# **Response to Ofgem's RII0-2 Sector Specific Methodology Consultation Western Power Distribution (WPD)**

14<sup>th</sup> March 2019

**Figure 2.3: Sources of RoRE performance against the baseline across four sectors**

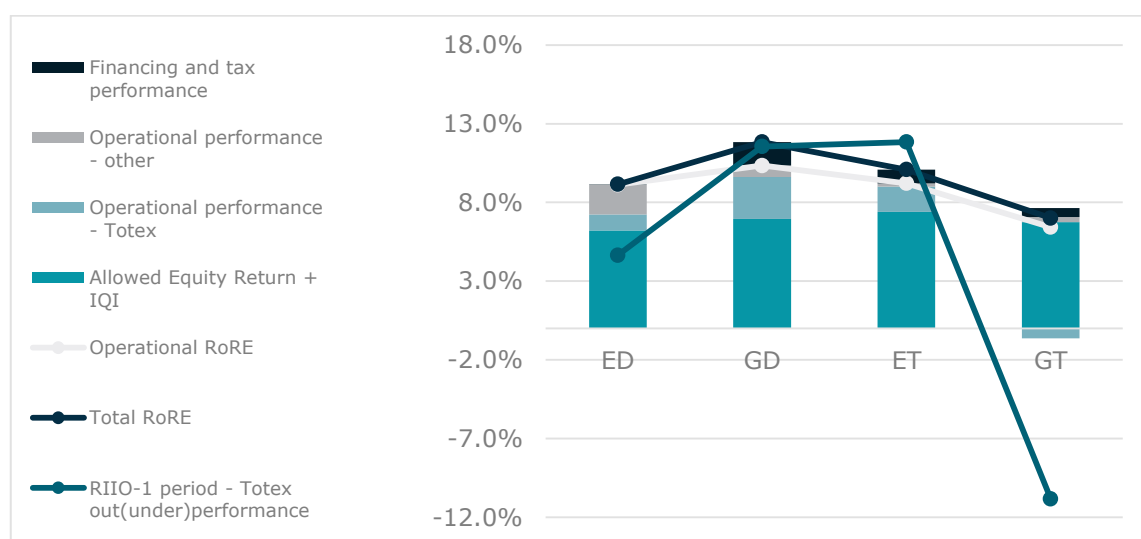
electricity transmission sector<sup>25</sup> and 11.84% for the gas distribution sector.<sup>26</sup> As illustrated in Figure 2.3, the drivers of these forecast returns are very different in each case.

**Figure 2.4: Indices used in Ofgem's RPE methodology-assumptions in RIIO-1 and outturn values**

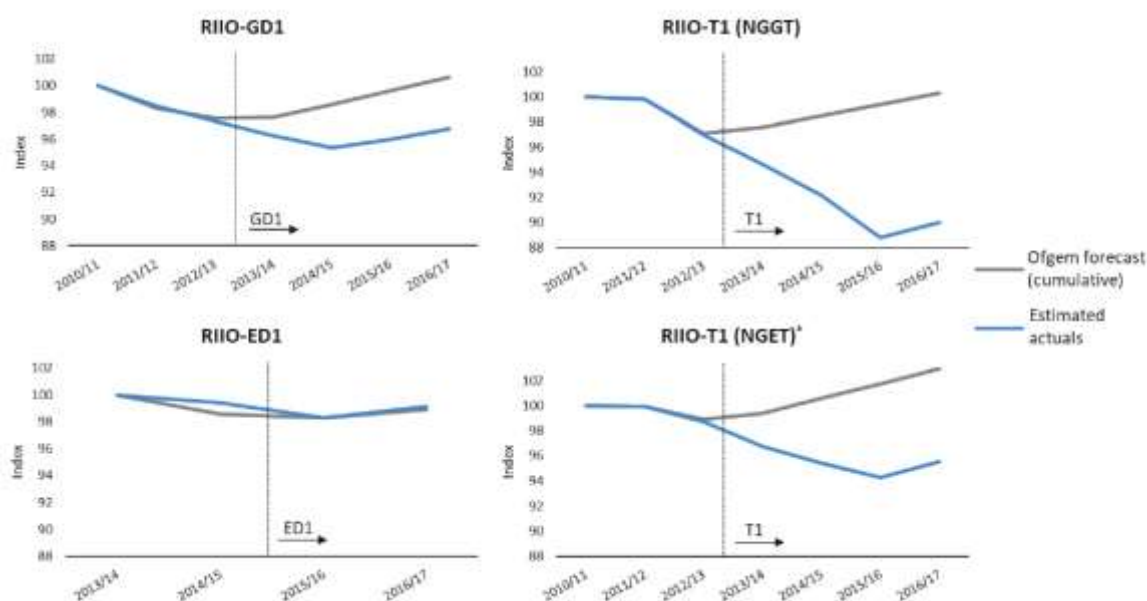
- 2.4.2 Ofgem used Real Price Effects to forecast inflation above the Retail Price Index (RPI) in RIIO-1. As illustrated in Figure 2.4 below, price inflation has been lower than expected and this has had a material impact on companies' costs and returns in certain sectors.<sup>37</sup>
- 2.4.3 According to CEPA's review, RPEs account for 80 basis points of additional RoRE for ET1, 40 basis points of additional RoRE for GT1, 70 basis points for GD1, and had a neutral impact on RoRE for ED1 over the years that the price control has been in place.<sup>38</sup>

- 2.4.4 While there was no systematic allowance outperformance in ED1, the underspends in GD1 and T1 are partly attributable to lower RPEs than those originally allowed by Ofgem. This suggests that some form of recalibration would be appropriate in RIIO-2.

**Figure 4.2: Incentive factor for Class 2 Anchoring for EMID**

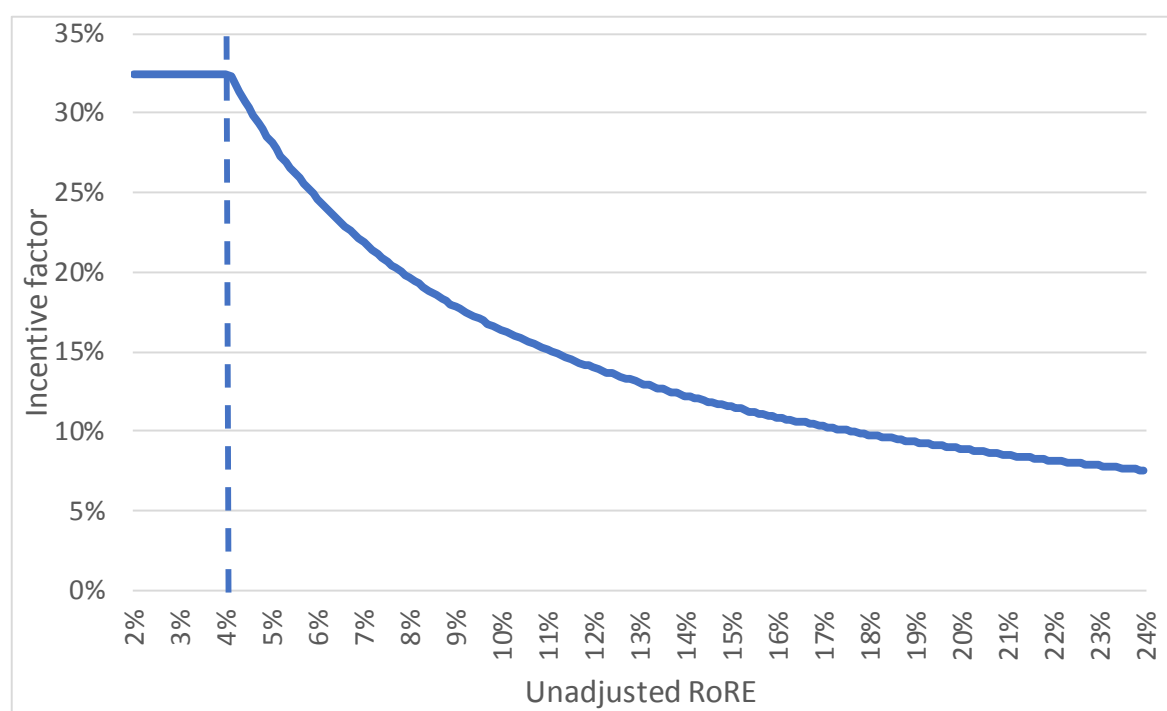
- 4.4.23 These results show the disincentive properties of overlaying a RAMs scheme (of any type) on energy networks. Any RAMs approach will reduce incentives for the sector to outperform.
- 4.4.24 However, under Class 2 RAMs there is an additional disincentive that will apply to companies in a sector where a small group of individual companies is skewing the average return above the threshold through action such as delaying expenditure. In this situation all companies in the sector potentially will be penalised by hitting the RAMs threshold at a lower level as shown in

**Figure 4.2 above (e.g. 4% instead of 6%). We understand that it is not Ofgem's intention to apply a higher RoRE reduction to a good performing company if the**

- 4.4.25 Figure 4.2 this is what will happen under Class 2 schemes as presently proposed.
- 4.4.26 Table 4.2 shows the sharing rates used in RIIO-1 and also Ofwat's PR19. All are materially above those effectively proposed by Ofgem for RIIO-2.

**Figure 5.1: Alternative proposals for Sculpted NARMS**

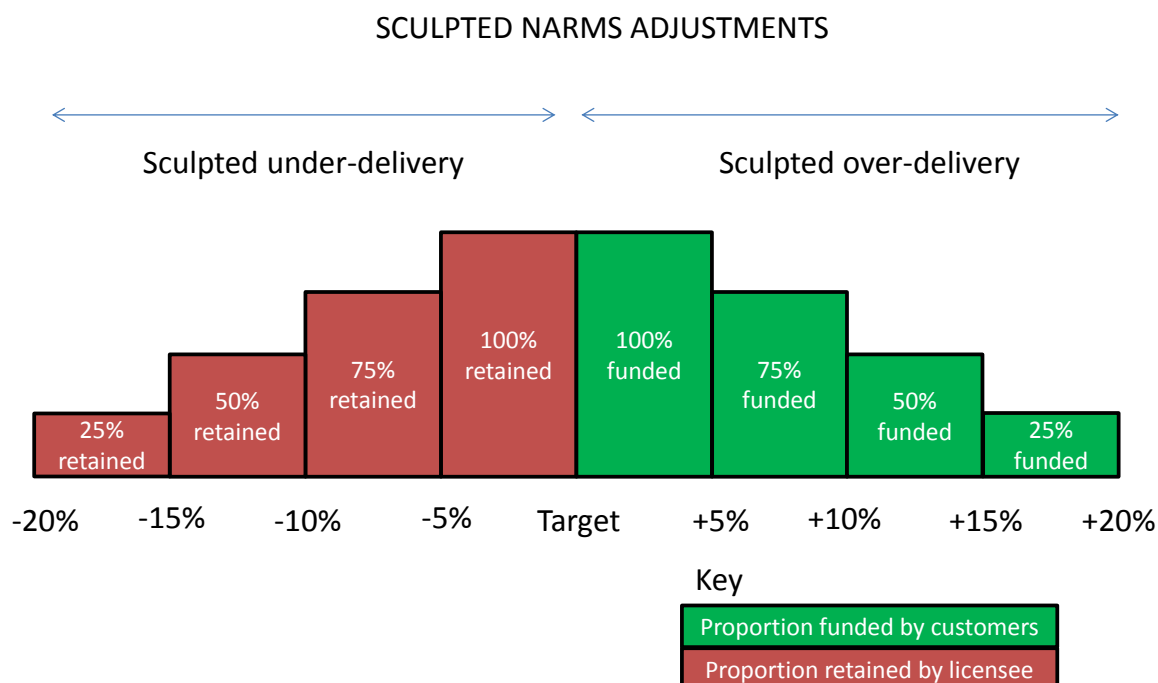
- 5.1.133 Rather than having different approaches to the valuation of over/under delivery, a sculpted approach using a consistent valuation rate could be applied (as described below). This is based upon valuation bands that reduce as the variance from target increases.

- 5.1.134 Within the first band 100% could be funded for over-delivery and 100% retained for under-delivery. In subsequent bands, lower percentages could apply as illustrated in the diagram below.

5.1.135 This has the advantage of incentivising the licensees to deliver within a band around the targets.

**Figure 5.2: Graph of submitted total expenditure versus our view of the efficient level, by DNO group**

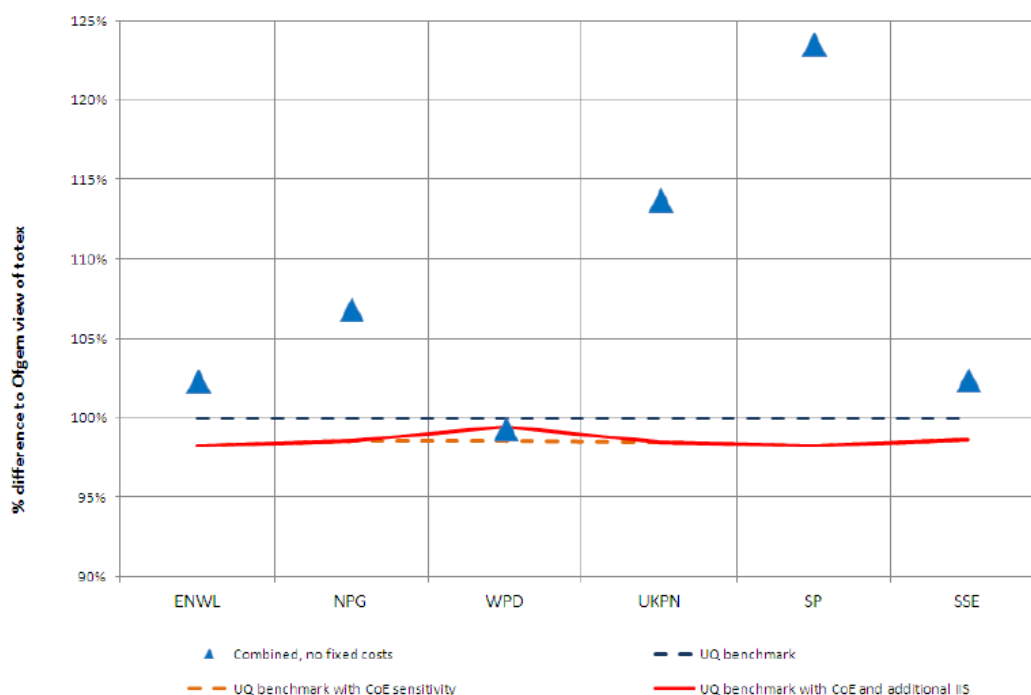
- 5.1.249 In previous price controls, Ofgem's view of costs has been informed by selecting certain benchmark parameters, some of which are based upon medians, but many of which are based on more stretching views such as upper quartile. This means that Ofgem's view is already biased towards lower costs.
- 5.1.250 The above categorisations suggest that a plan has 'good' costs where the licensee submits costs that are lower than the Ofgem view (based on stretching costs).

- 5.1.251 For a plan to be average, there is a narrow band proposed, between Ofgem's view and 4% higher. This means that a licensee will probably have to submit better than average costs to be classified as 'average'.
- 5.1.252 Due to the nature of Ofgem's benchmarking, the majority of submitted plans will therefore fall above the 1.04 ratio.
- 5.1.253 This means that most companies will be biased towards a 'poor' rating, rather than an 'average' rating.
- 5.1.254 This bias can be illustrated with reference to historical Ofgem analysis. The chart below is taken from Ofgem's fast track assessment of RIIO-ED1 business plans. WPD is the only company below 100% and would therefore be classed as 'good', ENWL and SSE are between 100% and 104%; half of the ownership groups NPG, UKPN and SP are all above 104% (representing half of the licensed entities).
